SUBJECT: DAVIS-BESSE NUCLEAR POWER STATION, UNIT 1: FINAL ACCIDENT
SEQUENCE PRECURSOR ANALYSIS OF FEBRUARY 2002 OPERATIONAL
CONDITION

Final Precursor Analysis

Davis-Besse	Cracking of Control Rod Drive Mechanism Nozzles and Reactor Pressure Vessel Head Degradation, Potential Clogging of the Emergency Sump, and Potential Degradation of High Pressure Injection Pumps	
Event Date February 2002	LERs 346/02-002, 346/02-005, and 346/03-002) CDP = 6×10^{-3}

RESPONSE TO COMMENTS

Figure 2. Medium LOCA Event Tree

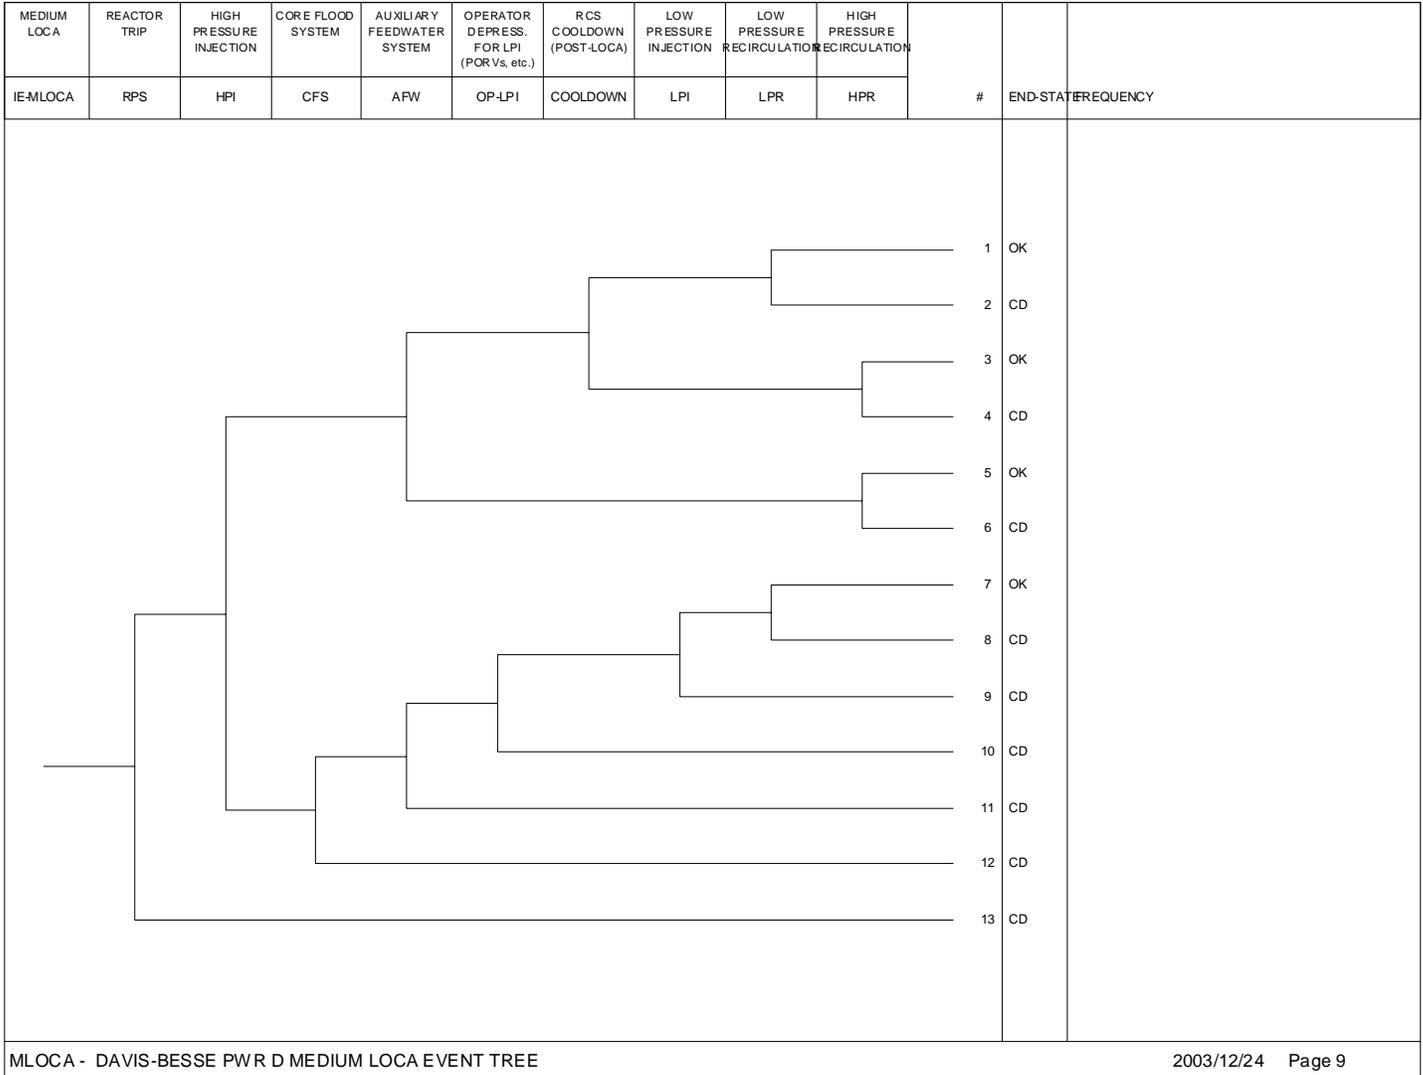
2. The event tree for medium LOCAs (Figure 2 on page 18) includes top events for auxiliary feedwater (AFW) and for cool down of the RCS. The implications of success for these events in the analysis include the following:
- If high pressure injection is unavailable, the cool down allows earlier inventory control by low pressure injection (LPI).
 - Successful cool down is modeled as a requirement to allow long-term cooling to be accomplished using low pressure recirculating (LPR). Otherwise, the event tree indicates that only high pressure recirculation (HPR) would be an option for long-term cooling.

There may be conservatism in the PSA and SDP with respect to the ability to avoid core damage in the event of a medium LOCA without HPI available. For the precursor assessment, however, a more significant impact is the assumption that active cool down would be needed to affect LPR in the long term. The expected response following a medium LOCA would be for the RCS to depressurize sufficiently such that, at the time of depletion of the borated water storage tank (BWST), LPR would be established.

If this change were to be made to the precursor analysis, medium LOCA sequence 4 would no longer be a core-damage sequence. This sequence comprises the second largest contribution to the CCDP, according to Table 1 and Table 3B of the preliminary precursor report. Removing this sequence would change the CCDP from 6.2E-3 to approximately 5.3E-3, and would reduce the importance from 6.1E-3 to approximately 4.4E-3.

Response: Changes to the event tree were considered, but do not appear to be justified. The SPAR models for all B&W plants require active heat removal prior to entering LPR. We have no information that proves that using HPI until the criteria for shifting to recirculation are met will always result in the plant being depressurized. In order to justify the change to the event tree, the licensee would have to prove that operators would never use HPR following a MLOCA.

The RCS cool down top-event (COOLDOWN) is included in sequences in which AFW is successful. The dominant event in the COOLDOWN fault tree is the operator failing to cool down the plant to LPR pressure. The cutsets and accident sequences that credit depressurization following failure of HPR are realistic, based on our understanding of plant procedures and response.
